SEGA OF AMERICA, INC.
Consumer Products Division

32X H/W Information

Doc. #-MAR-25-R5/R6-060694

(2) Crystal exchange of the main board

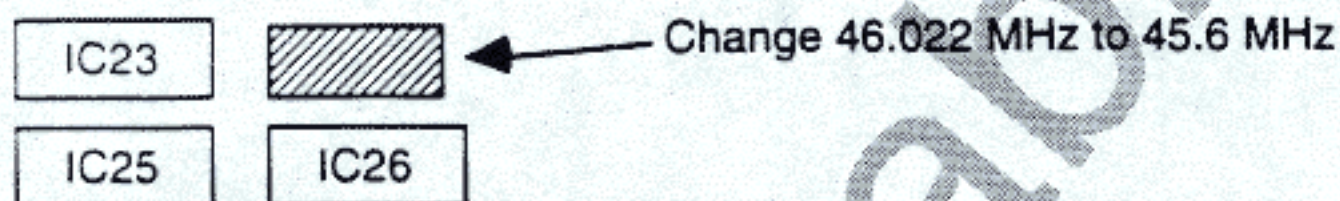
9. The following countermeasures should be performed in response to PAL.

• For Target Ver. 1.0

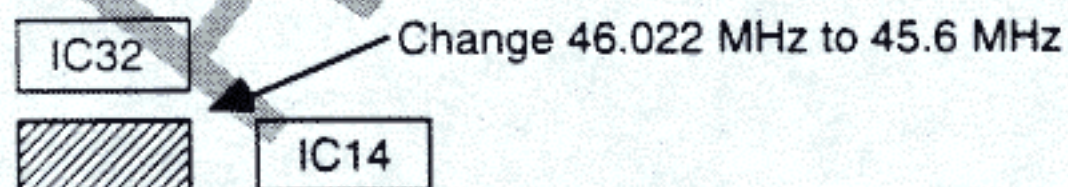
• For Target Ver. 1.1

(1) (2) are the same as in Target Ver. 1.0.

• Modification Method of the 32 Mbit SRAM W/BUP Board

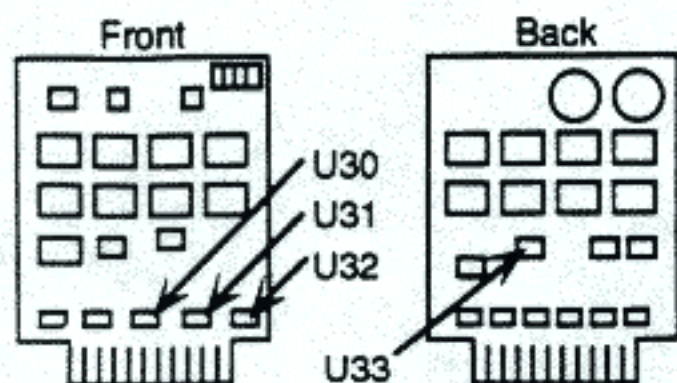
3. Precautions when using a 32 Mbit SRAM board.
 - The 32 Mbit SRAM W/BUP board mis-reads data on the SH2 RAM board when both 68000 and SH2 are running.
 - The modifications on the next page are required for 32X development.
 - There are no problems when running 68000 and SH2 independently.
 - There is no need for modifying MD development.

Work Procedure

1. Lift pin 1 of U31 and U32.
2. Lift pins 13, 14, and 15 of U33.
3. Add jumper between pin 16 of U30 and pins 13 and 14 of U33.
4. Connect pin 15 of U33 to GND (pin 8).
5. Add jumper between pin 9 of U33 and pin 1 of each U31 and U32.
